# PRODUCT BULLETIN #506

## 8,000 LBS. SLIPPER SPRING FOR DEX-TREME® D160 AXLES

November 25, 2024

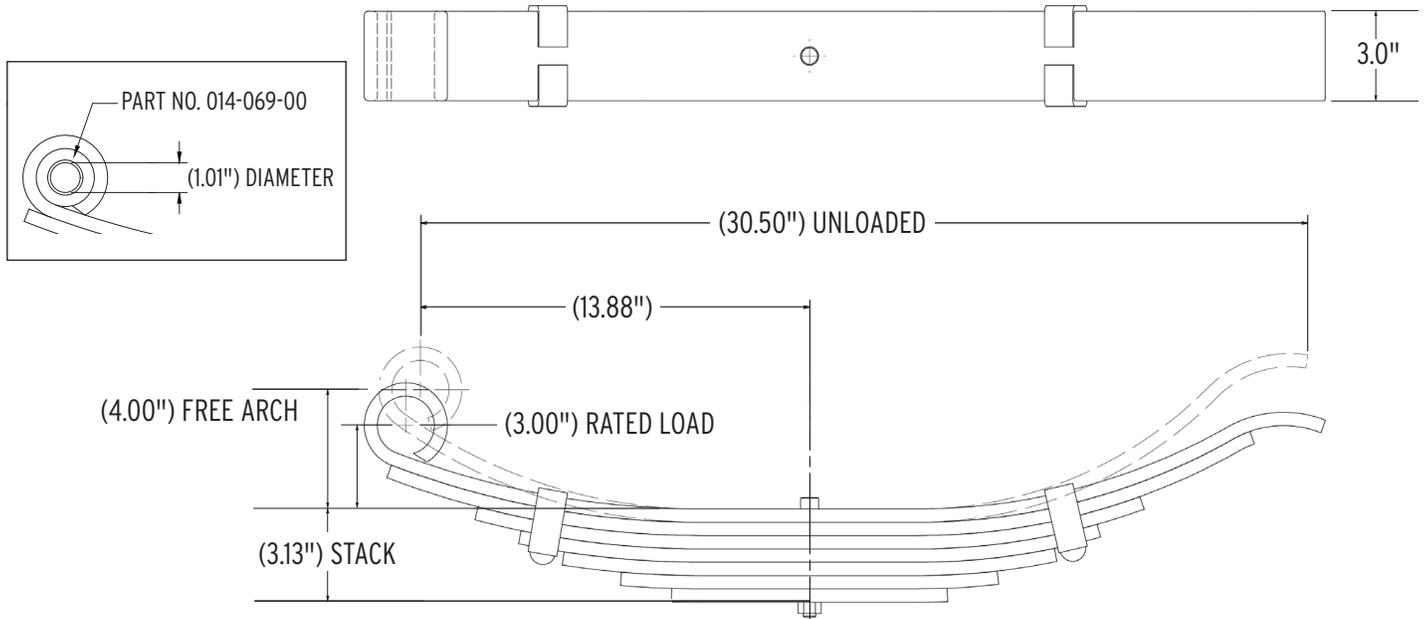
Dexter is proud to introduce a new 3" wide slipper spring rated at 8,000 lbs. for the Dex-treme® D160 axle.

The spring is offered in addition to the existing Dexter HDSS and DexAir® suspension for the D160. To match the new 8,000 lbs. slipper spring, several hanger and attaching part kits (HAP) have had their capacity rating increased to 16,000 lbs. per axle.
